ELECRAFT Application Note

Improving the Immunity of the Rear-Panel RS232 and Audio Connectors to RF

Figure 3. Audio I/O Module Choke Locations.

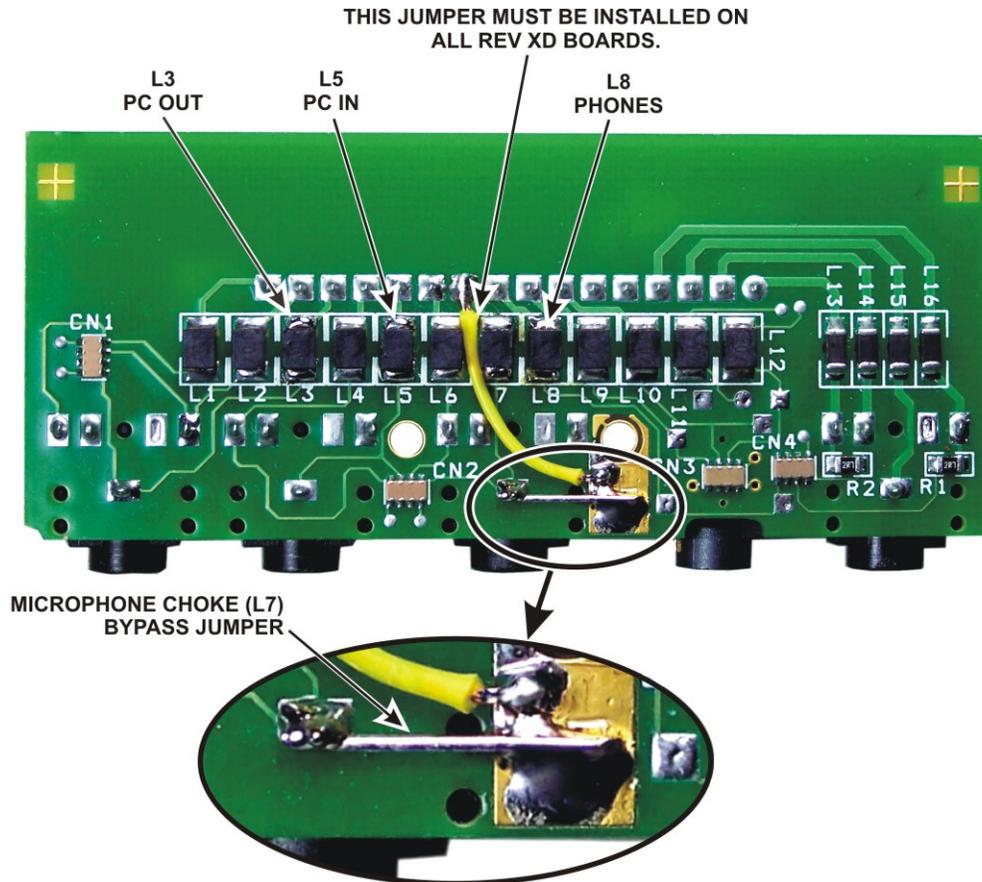
☐ If you have a revision XD Audio I/O module, ensure the long jumper shown in Figure 3 is installed. The revision is printed on the top side of the board. Install the jumper if it is missing.

☐ Install the MIC ground choke bypass jumper on the Audio I/O module as shown in Figure 3 using a short piece of wire such as a discarded component lead.

☐ If you wish to bypass the ground chokes for the PC OUT, PC IN and PHONES jacks (L3, L5 and L8 on the Audio I/O Module shown above), you can remove the chokes and replace them with short jumpers across the solder pads or you can fashion a wire jumper that goes over the existing choke as shown in Figure 4.The chokes are glued to the board as well as soldered. If you do not have proper tools to remove them safely without damaging the traces on the board, we recommend you use the wire jumpers shown. They are as effective as removing the choke. Be sure the loop passing over the choke does not stand more than 3/16" (4.7 mm) above the board. If it is higher it may strike the transformers on the main KIO3 board.

Figure 5. RS232 Ground Choke on the Remote I/O Module.

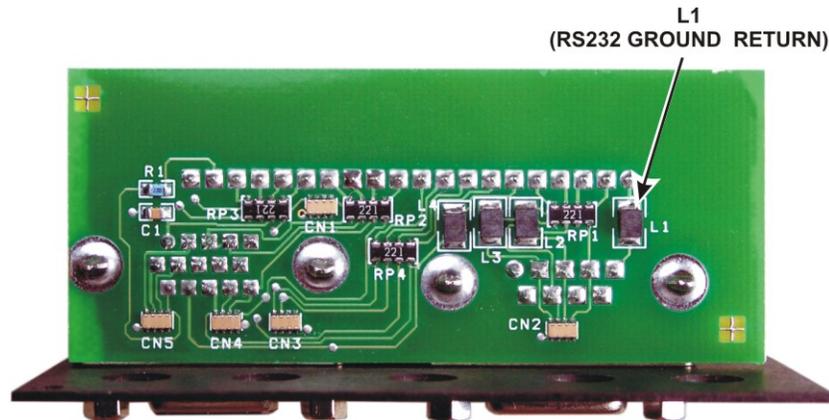
☐ If you wish to bypass the ground choke for the RS232 connector, jumper L1 on the Remote I/O Module (see Figure 5).
